Access Compliance Report Public Rights-of-Way (Curb Ramps)

Main Street: BRADBURY_RD Cross Street: SEAL_BEACH_BLV Location: SE

ADA ID: RPRK211221110906 Ramp Type: Type 4 - Parallel Initial Pass/Fail: Fail Overall Compliance: No Severity Score: 15

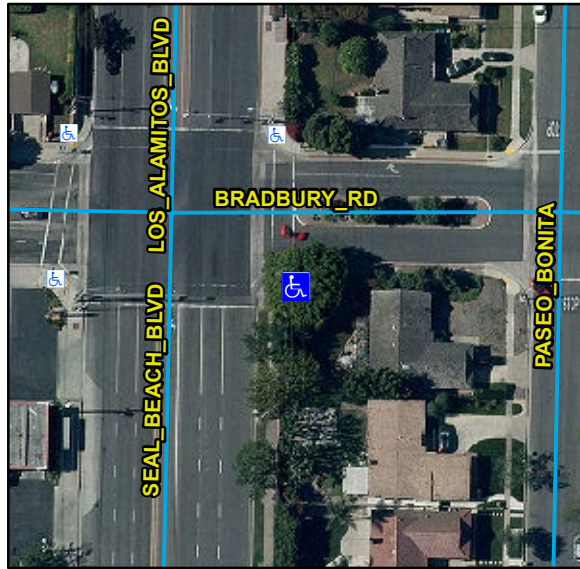
R304.5.3, STD 1115

Remove & Replace Curb Ramp With Two New Directional Ramps or Equivalent.
